Access Compliance Report

Public Rights-of-Way

Intersection ID: 24374	Main Street: BEVERLY_CREST_BV	Cross Street: HUGH_FOREST_RD	Location: W
ADA ID: 450C5BB6AA3E	Ramp Type: Perp	Initial Pass/Fail: Pass	Overall Compliance: No
Severity Score: 22.75			
Codes/Mitigation Info/Possible Solution		Field Measurements/Component Compliance

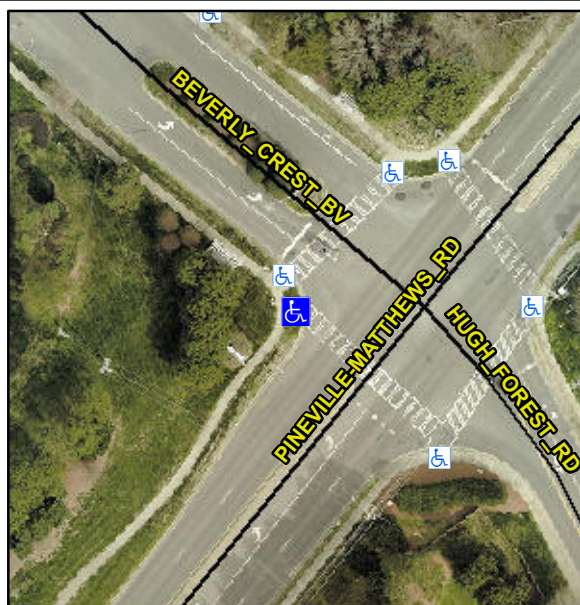
**Not Found, R304.5.3, R305.1.4,
R305.2, R302.7.2, R304.5.4**

Compliance	Description	Data	Compliance	Description	Data
N/A	Ramp Length (in)	96.0	Yes	Ramp Slope (%)	8.0
Yes	Ramp Width (in)	72.0	No	Ramp XSlope (%)	3.4
N/A	Flare Type LT	Sloped	N/A	Flare Type RT	N/A
N/A	Flare Slope LT (%)	7.0	Yes	Flare Slope RT (%)	1.4
N/A	Flare Traversable LT?	Yes	N/A	Flare Traversable RT?	Yes
Yes	Landing Length (in)	60.0	Yes	DWS Provided?	Yes
Yes	Landing Width (in)	72.0	Yes	DWS Contrast?	Yes
Yes	Landing Slope (%)	1.1	Yes	DWS Length (in)	25.5
No	Landing X Slope (%)	2.9	No	DWS Full Width?	No
N/A	Landing Curb? (Y/N)	No	No	DWS Offset (in)	3.0
N/A	Shared Landing?	No			
Yes	Gutter Ponding?	No	No	Gutter Slope (%)	5.9
No	Gutter Lip Ht (in)	2.0	Yes	Gutter X Slope (%)	0.7
N/A	Painted X Walk1?	Yes	N/A	Painted X Walk2?	N/A
	X Walk 1 Direction	To SE		X Walk 2 Direction	N/A
N/A	X Walk 1 Width (in)	112.0	N/A	X Walk 2 Width (in)	N/A
	X Walk 1 Slope (%)	1.4		X Walk 2 Slope (%)	N/A
	X Walk 1 X Slope (%)	0.1		X Walk 2 X Slope (%)	N/A

Yes	Ramp inside XWalk1?	Yes	N/A	Ramp inside XWalk2?	N/A
	Road Slope (%)	N/A	N/A	Clear Space?	Yes
	Road X Slope (%)	N/A	N/A	Clear Space to XWalk (in)	N/A
Yes	Any Obstructions?	No	Yes	Storm Grate/Utility Hazard?	No
	Obstruction Type			Storm Grate/Utility Type	
		N/A			N/A
			Yes	Surface Condition? (G/P)	Good

**Remove & Replace Entire Ramp.
Remove & Replace Gutter.**
